SYDNEY METRO PITT STREET SOUTH OVER STATION DEVELOPMENT

Response to Submissions (SSD
10376 & SSD 8876-2)

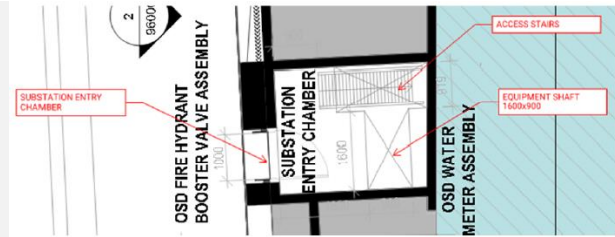
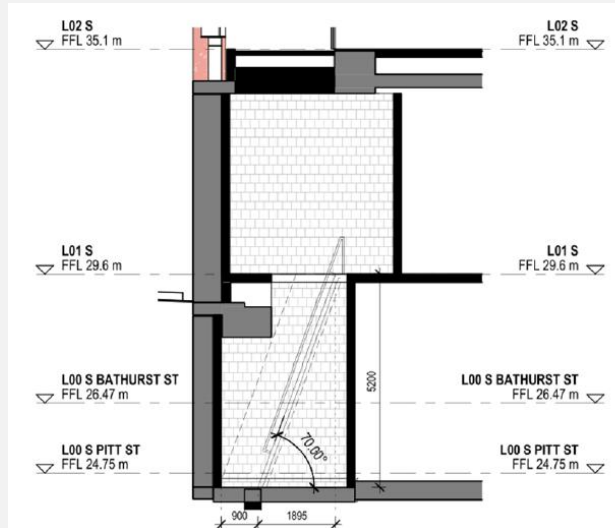
<p>b) The OSD substation is located on Level 1. The drawings show doors opening outwards above the awning – is this to hoist a transformer over the awning? A sturdy material for the awning must be proposed as such.</p>	<p>The substation is located on Level 1. Major equipment within the substation includes transformers, high-voltage ring-main-units and low-voltage switchboards. Ausgrid has specific requirements for personnel and equipment access and egress.</p> <p>Primary personnel access will be via dedicated access stairs from Pitt Street.</p> <p>Secondary personnel access, small equipment access (up to 70kg) and heavy equipment (up to one tonne, including high and low-voltage switchgear) will be via access chamber and ladder from Pitt Street as illustrated below.</p>

The equipment shaft will have a permanent lifting beam for loads up to 1200kg. A gantry crane mechanism will be stored elsewhere in the building and fitted by the building owner when required for use by Ausgrid. Transformers and major plant will be moved into the substation using "Preston Hire – Superdeck 2.2" temporary platforms. These will extend over the building awning as shown in the substation layout drawing below. Louvred doors opening in the façade will provide access for the platforms. Once inside the substation, final manoeuvring of the transformers will be accomplished using heavy load skates.
